Product / Process Change Notification (PCN) Major change			
☐ Minor change			
PCN #:	PCN_WCAP-ASNP_20220421	Change Category:	
Affected Series:	WCAP-ASNP; 865250xxxxxx	□ Equipment / Location☑ General Data□ Material	
PCN Date:	January 21, 2022	□ Process	
Effective Date:	April 21, 2022	□ Product Design□ Shipping / Packaging□ Supplier□ Software	
Contact:	Product Management	Data Sheet C	hange:
Phone:	+49 (0) 7942 - 945 5001	⊠ Yes	□ No
Fax:	+49 (0) 7942 - 945 5179	Attachment:	
E-Mail:	pcn.eisos@we-online.com	□ Yes	⊠ No
DESCRIPTION AND PURPOSE OF CHANGE:			
Because of a database mismatch, Würth Elektronik will update all datasheets for the Matchcode WCAP-ASNP.			
The component Marking will be changed to the current state of art.			
DETAIL OF CHANGE:			
Datasheet Update Würth Elektronik will update the datasheet layout in general for all WCAP-ASNP datasheets. (This is a datasheet correction only. There will be no change in form, fit, function, quality or reliability of the product.)

Example old Drawings with indirect dimensioning

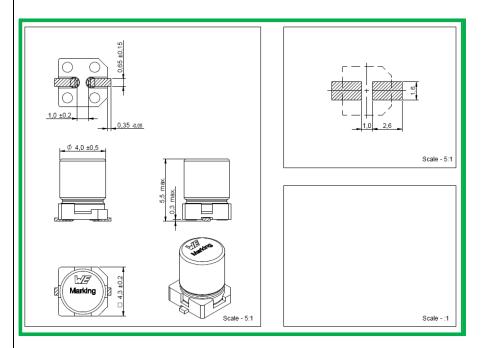
• In order to visualize the corrections of the dimensions example of the old and the new drawings is shown below. Würth Elektronik will update the dimensioning from an indirect dimensioning to a direct dimensioning:

Example new drawings with direct dimensioning
